UNITED STATES PATENT AND TRADEMARK OFFICE

10/579,257

Office Action Summary	Application No. 10/579,257	Applicant(s) SCHEDLER, HUBERT	
	Examiner James English	Art Unit 3616

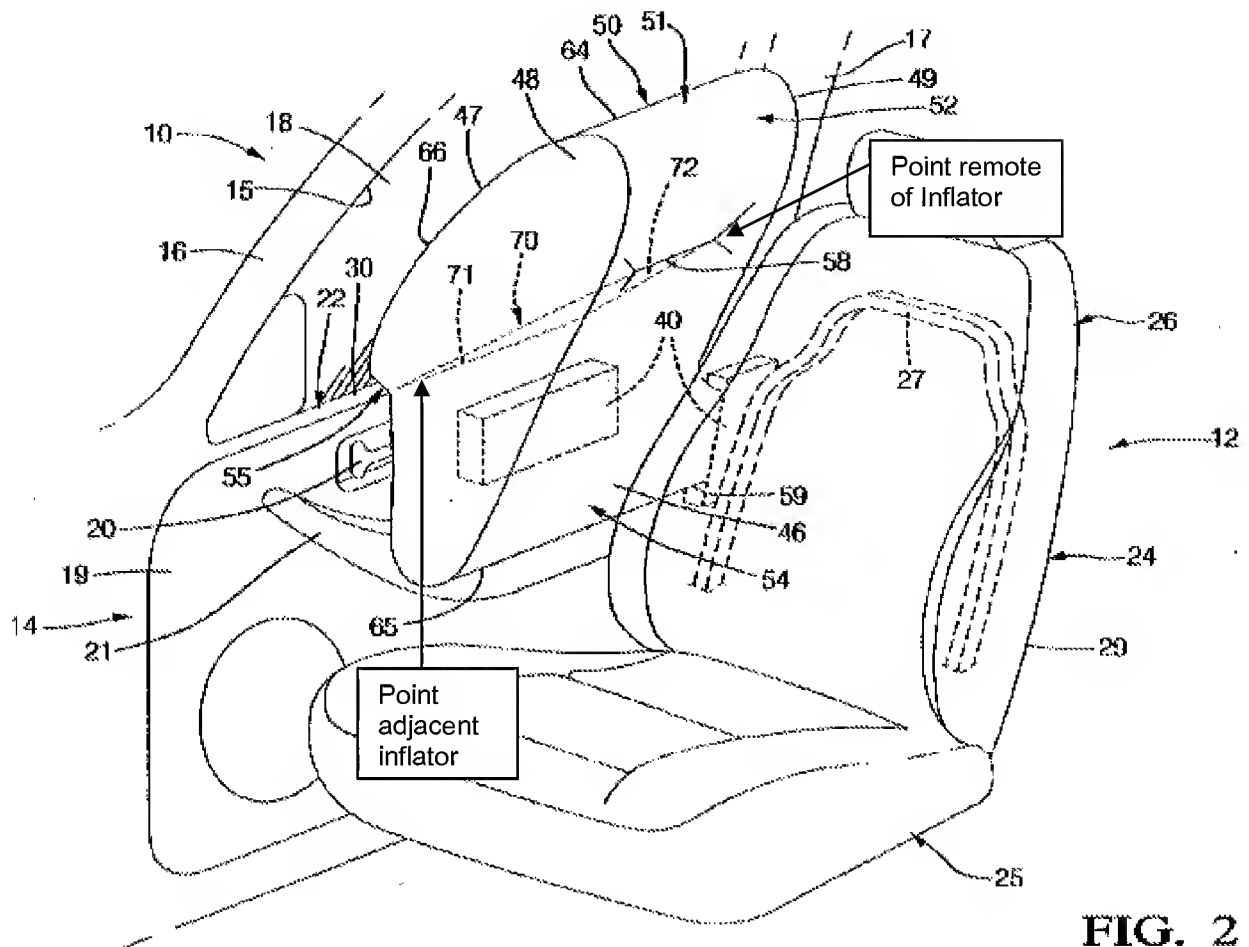
With respect to claims 1, 3 and 10, Spencer et al. discloses a side airbag module (40) that has a cushion (50) with forward and rearward faces (48, 49) which may be made of separate panels sewn to the central cushion fabric (51). (Column 4, lines 26-29.) Spencer et al. further discloses a tether (70) with a first end (71) secured to the outboard contact face (47) of the cushion (50) and a second end (72) connected to the inboard contact face (46) of the cushion (50). (Fig. 5, column 6, lines 5-10.) This is

analogous to an airbag formed of interconnected layers (48, 49, 51) comprising an internal tether (70) having two ends (71, 72) to interconnect two spaced apart regions of the interior of the airbag (46, 47), wherein the distance around the periphery of the airbag, in horizontal section, between the ends of the tether (70) is greater in one direction than in the other direction and the length of the tether is less than the distance in the other direction (Fig. 5). Spencer et al. further discloses the airbag module (40) having a housing (60), inflator (42) and cushion (50). (Fig. 3, column 3, lines 62-64.) This is analogous to the airbag (50) including a portion to receive a gas generator (42) arranged to inflate two spaced-apart regions extending therefrom (Fig. 4), with the tether (70) extending from a point adjacent the portion configured to receive the gas generator (42) to a point within the interior of the airbag remote from the gas generator (42). (Modified Fig. 2 - below.)

With respect to claim 5, Spencer et al. discloses the cushion (50) includes forward and rearward faces (48, 49) which may be made of separate panels sewn to the central cushion portion (51). (Column 26-29.) Spencer et al. further discloses the airbag module (40) having a housing (60), inflator (42) and cushion (50). (Fig. 3, column 3, lines 62-64.) This is analogous to the airbag (50) is formed from two superimposed substantially identical layers of fabric (48, 49) interconnected by a peripheral seam, the internal tether (70) extending from part of the peripheral seam to a point adjacent the portion configured to receive the gas generator (42). (Modified Fig. 2 - below.)

With respect to claims 16, Spencer et al. discloses the cushion (50) includes forward and rearward faces (48, 49) which may be made of separate panels sewn to the central cushion portion (51). (Column 26-29.) Spencer et al. further discloses the airbag module (40) having a housing (60), inflator (42) and cushion (50). (Fig. 3, column 3, lines 62-64.) This is analogous to the airbag (50) is formed from two super-imposed substantially identical layers of fabric (48, 49) interconnected by a peripheral seam, the internal tether (70) extending from part of the peripheral seam to a point adjacent the portion configured to receive the gas generator (42). (Modified Fig. 2 - below.)
